6.2 Schematic Diagram

49.860MHZ VERSION
22/04/98.
05/05/98. REV A.

MODEL NO	RC ROBOT
PART NAME	TX-SCHEMATIC (27MC/49MC)
P/N	ME-SC-0043- 01
DRAWN BILLY LEE	CHECKED APPROVED
Dynamic industries co. ltd.

Figure 6.2 Schematic Diagram

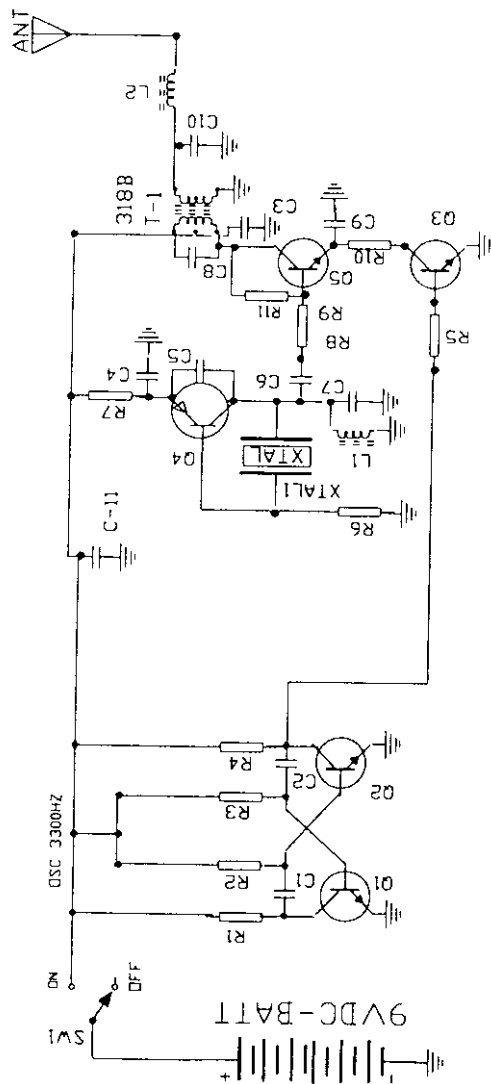
1. R6 220K WAS 47K
2. R7 1K WAS 470 OHM
3. R8 CANCELLED WAS 680 OHM
4. R11 47K ADDED
5. R9 150 OHM WAS 10 OHM
6. C11 0.01UF ADDED.
